REPORT TO THE CHIEF ENGINEER
ON
WATER PERMIT APPLICATION NO. 2685-2
POWERTECH (USA) INC.
November 2, 2012

United States Nuclear Regulatory Commission Official Hearing Exhibit			
In the Matter of:		POWERTECH USA, INC. (Dewey-Burdock In Situ Uranium Recovery Facility)	
	ASLBP #:	10-898-02-MLA-BD01	
	Docket #:	04009075	
	Exhibit #:	APP-028-00-BD01	
	Admitted:	8/19/2014	
	Rejected:		
	Other:		
		Identified:	8/19/2014
		Withdrawn:	
		Stricken:

**RECOMMENDATION OF CHIEF ENGINEER FOR WATER PERMIT
APPLICATION NO. 2685-2, Powertech (USA) Inc.**

Figure 3. DENR-Water Rights observation well completed into the Madison aquifer located approximately 10 miles northeast of the project area proposed by Application No. 2685-2.

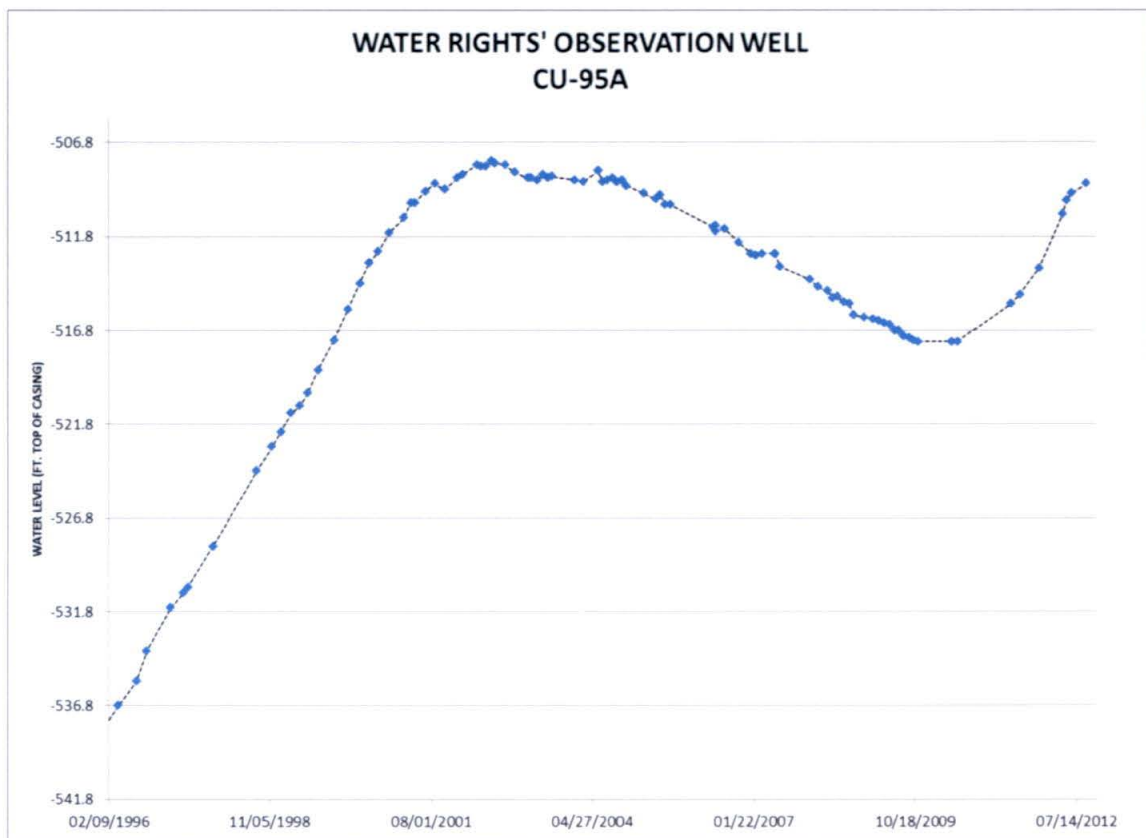
The Water Rights Program monitors 26 observation wells completed into the Madison aquifer in the Black Hills area (Water Rights, 2012a). This project area is located within approximately 15 miles of two Water Rights’ Observations completed into the Madison aquifer. Hydrographs for the wells show the aquifer’s response to climatic conditions and clearly demonstrate the system is recharged, (see figures 3 and 4).

Observation well data for the Madison aquifer documents: 1) upward trending water levels; 2) that at the current level of development, climatic conditions greatly mask any temporal effects of well withdrawals thus the combined recharge to and natural discharge from the Madison aquifer significantly exceeds long term well withdrawals; and 3) the potentiometric surface of the aquifer has been relatively unchanged over time. Therefore, the observation well data shows that unappropriated water is available from the Madison aquifer.

Figure 5. Drawdown predicted from a well pumping 551 gallons per minute from the Madison aquifer, continuously for one year, assuming $T = 3,000 \text{ ft}^2/\text{d}$, $S = 2 \times 10^{-4}$, $t = 20 \text{ yrs.}$ (modified from ("Theis Equation Calculator"))

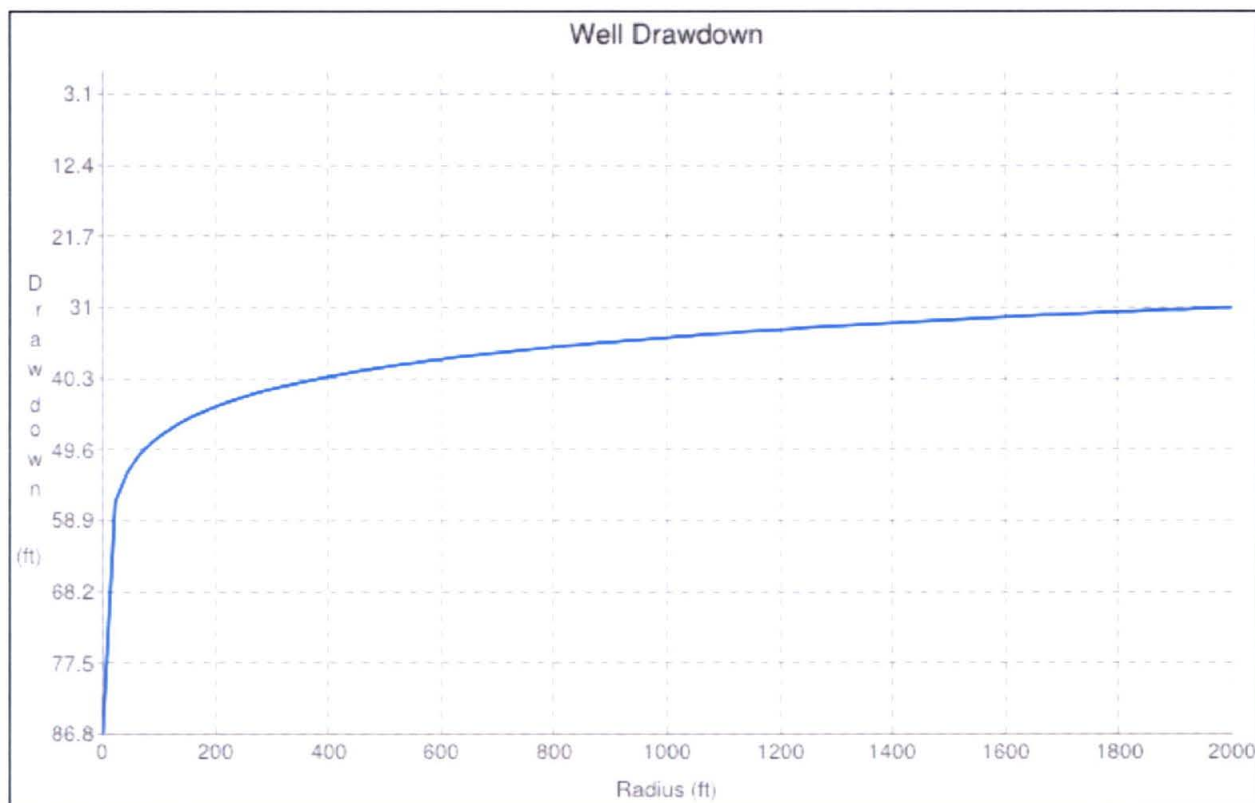
Applying the transmissivity and storage coefficient (i.e. $T = 3,000 \text{ ft}^2/\text{d}$; and $S = 2 \times 10^{-4}$) estimated for the Madison aquifer in this area (Woodward-Clyde Consultants, 1980), the drawdown 1,000 feet

from a well pumping 551 gpm would be less than 35 feet after twenty years of continuous pumping based on the Theis Equation (see Figure 4) ("Theis Equation Calculator"). Since the transmissivity for this area is likely higher than 3,000 ft²/d, drawdown would be less than predicted by the Theis Equation. The Theis equation requires a number of simplifying assumptions, some of which may not apply in this case however, the solution is still useful.
